RESPONSE LETTER

Flatt Point Subdivision (OPA, ZBA, DPS, DPC) - 3401 County Road 13

Prince Edward County

Technical Review Comments (March 4, 2026)

Concept Plan

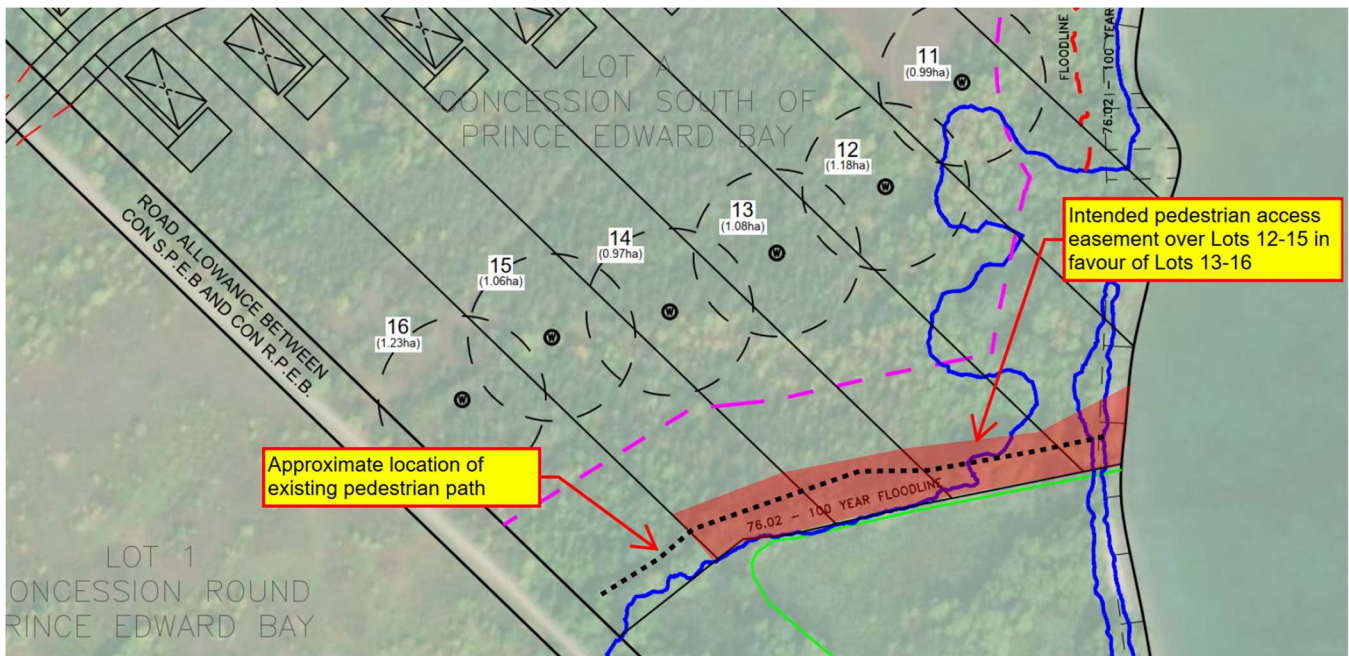
4. COMMENT: *The previous submission contemplated using Lot 17 as a private park. As this is no longer proposed, staff are concerned about the lack of shoreline access and*

recreational opportunity for Lots 12-16. The Planning Addendum Letter indicates that Block 18 can be used for beach access. Given the depth of the proposed lots, consideration should be given to the establishment of a reciprocal easement for Lots 12-16 to the north of the wetland. This would also provide flexibility for a future boathouse or communal dock which are not permitted in the Environmental Protection (EP) Zone. Alternatively, please verify that the Conservation Authority would issue a permit for any required regrading/fill to establish an accessible pedestrian path.

RESPONSE: As discussed at our meeting with Staff on March 12, a reciprocal access easement can be provided over Lots 12-15 to the north of the wetland, providing pedestrian access for Lots 13-16 to the common Block 18 shoreline area – this is illustrated in the figure below.

The typical approach to provide this easement is identify it as a condition of Draft Plan of Subdivision approval, with an R-Plan prepared to delineate the extent of the easements, which are then included as part of the legal description of the lots at the time of subdivision registration. We would suggest that a condition to this effect be included in the recommended Conditions of Draft Plan approval, with wording identifying a minimum width and intent (e.g. no less than 6 metres in width and suitable for providing pedestrian access to Block 18).
